CITY OF MIAMI
ADDENDUM NO. 2
October 23, 2009

**DESIGN BUILD SERVICES FOR THE
DESIGN AND CONSTRUCTION OF BISCAYNE SKATE PARK
RFP No. 08-09-068**

CONCEPTUAL RELATIONSHIPS
FUNCTIONAL DIAGRAM NOT TO SCALE

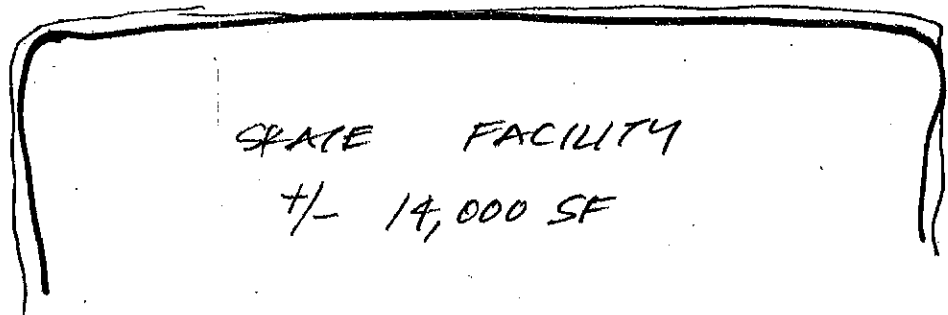
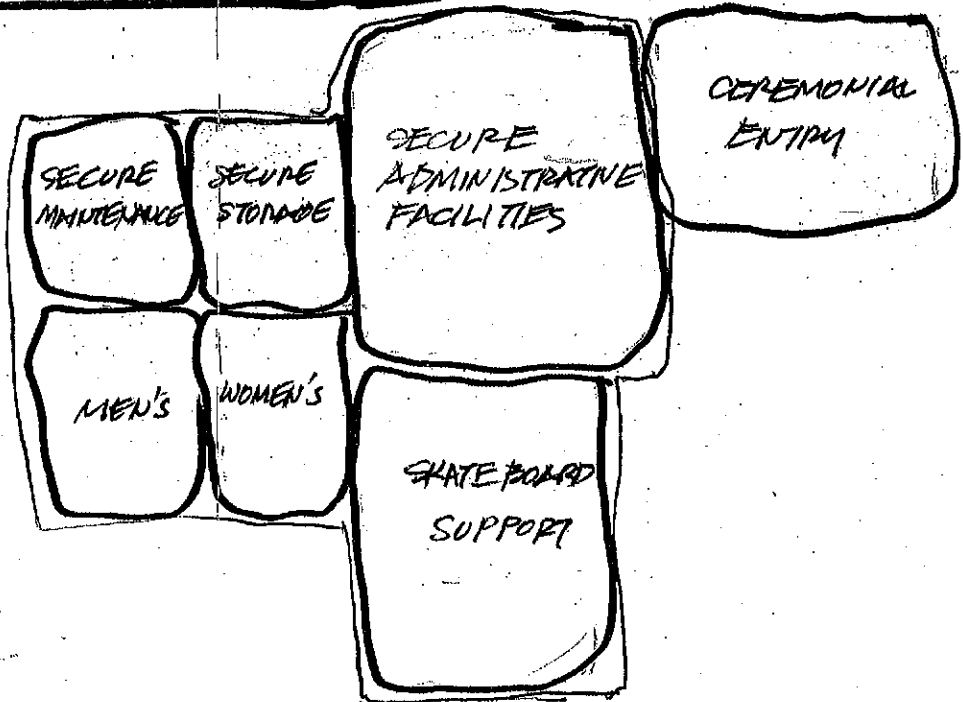
Question	2	Responses to bidder's questions do not provide the basic information required for a Proposer to provide an accurate proposal to the City. Per CCNA, Florida Statutes 287.055 paragraph (j), please provide "survey information concerning the site, interior space requirements...schematic layouts and conceptual design criteria of the project... design and construction schedules, site development requirements, provisions for utilities, stormwater retention and disposal and parking requirements applicable to the project."

Answer	2	All but the following have been addressed in the DCP: <ul style="list-style-type: none"> • Existing survey is hereby provided. • Two bubble diagrams are provided; however, due to the unique nature of the project, schematic and design concepts for some components have not been provided. It is the responsibility of the Proposer to create the concept and layout of the park components. • Stormwater retention and disposal- It would be acceptable to have the first two or three inches of runoff detained in low areas as a part of a creative site design, that might include some wetlands plants in designed/planned low lying areas. Such a design approach would also likely be seen as a "positive" ecologically. • Parking for a minimum of 20 cars should be provided.
